Effectiveness of Groundwater Cleanup Efforts at Pantex – the Southeast Contaminant Plume

STAND
Technical Report 2008-3

Prepared for STAND

By George Rice

Figure 2.3
RDX in Perched Aquifer

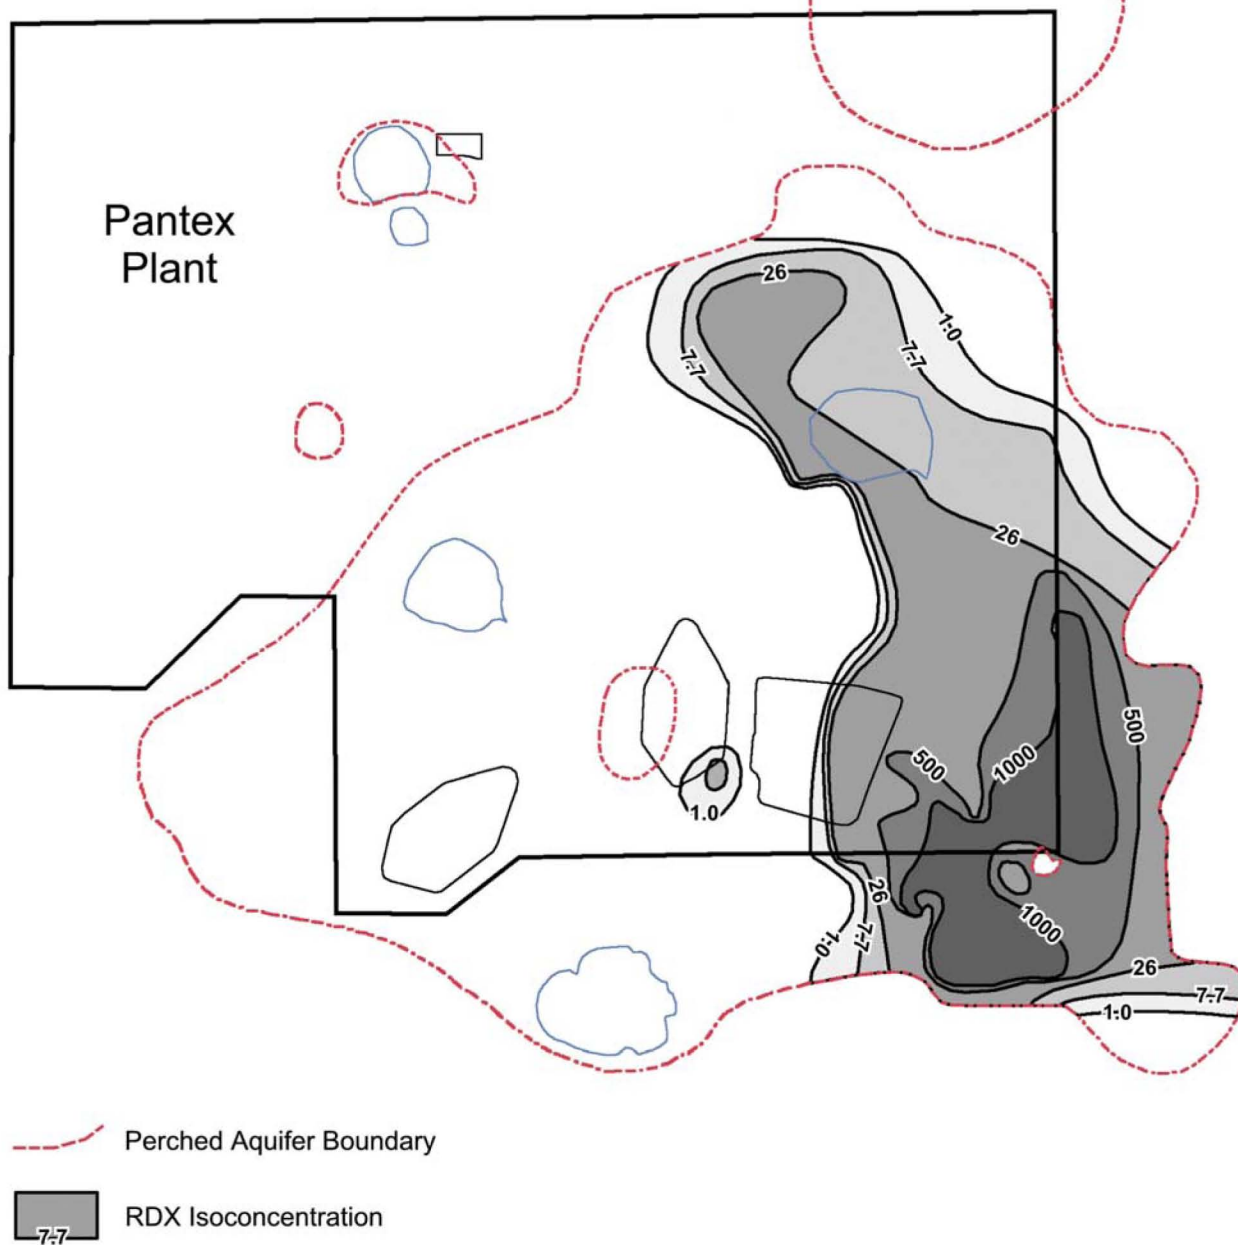
Contaminants have been found in all four bodies of perched groundwater beneath Pantex (landfills, Playa 3, Pratt Playa, main)^{22, 23}. DOE distinguishes two zones of contamination within the main body of perched groundwater: the southeast zone, and Zone 11. The southeast zone covers Playa 1 and the area around Zone 12, including contaminated groundwater that has migrated beyond the plant boundaries to the east and southeast. Zone 11 covers a relatively small area near Zone 11. This report focuses on the southeast zone. RDX is the most widespread contaminant in the perched aquifer. The extent of the RDX plume is shown in figure 2.3.

Figure B-1
Removal of High Explosives from the Southeast
Contaminant Plume

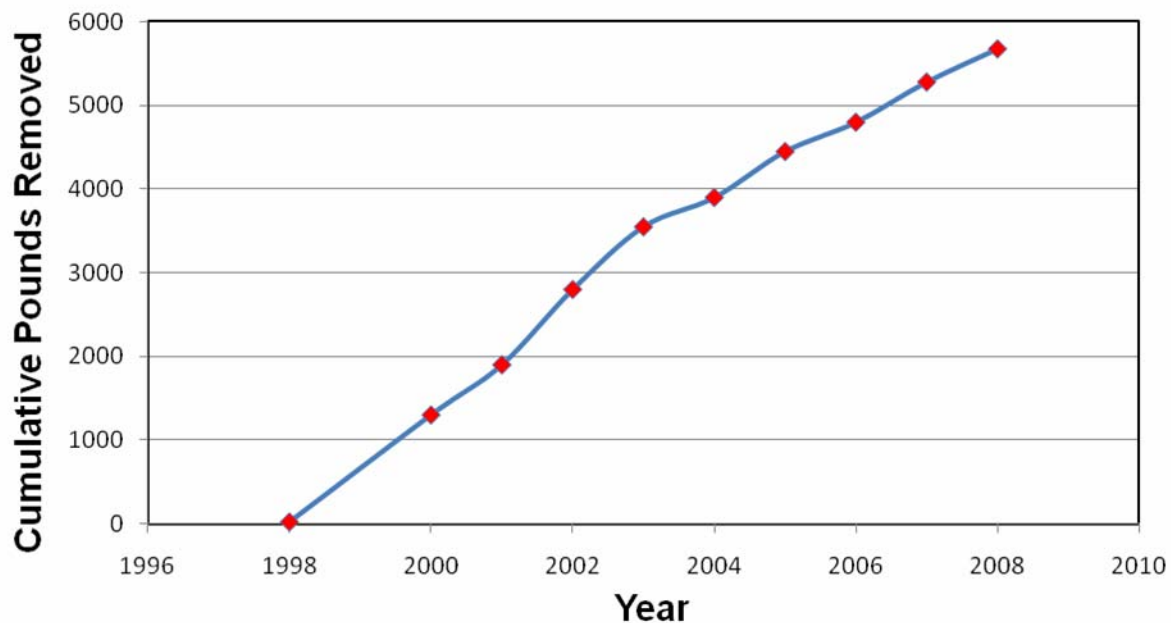
Through March 2008, approximately 5700 pounds of high explosives (e.g., HMX, RDX, TNT) have been removed from the southeast plume (figure 3.1)²⁶.

Overall, the treatment systems have been only marginally effective⁵⁰. Although approximately 5700 pounds of high explosives have been removed since 1995, this is a relatively small portion of the 95,000 pounds of RDX that DOE estimates is present in the perched aquifer and vadose zone.
